Architectural Review Committee Staff Report Meeting Date: November 25, 2025

PETITION: Shoppes at Brookside Multi-tenant Retail Building Architectural Design

REQUEST: Petitioner requests approval of their design for a new multi-tenant building

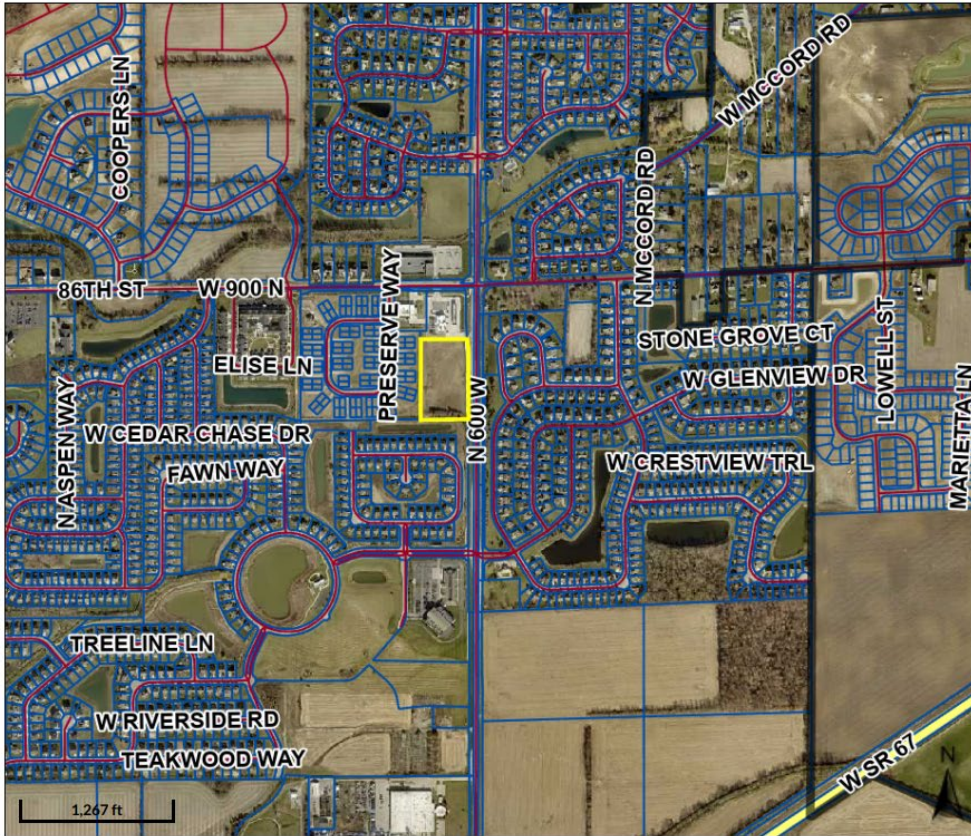
1. **Façade articulation:** The north and south façades includes articulation but does not meet the overlay's minimum 3-foot depth requirement. *The ARC may approve this as proposed without a Development Standards Variance.*
2. **Doors & Frames:** The petitioner intends to match the first building's dark bronze aluminum frames, storefront doors, and glazing system. *Staff would just like to confirm this at the meeting.*

- Staff would like to gauge the ARC's perspective on the lack of awnings on the front façade.
- The awning shown for the south façade is listed as optional. Staff feels this should be required as its weather covering for the drive-thru window and adds additional "character" to the south façade.
- Request verbal confirmation from the petitioner on item #2 above.
- The ARC must vote on item #1 above.
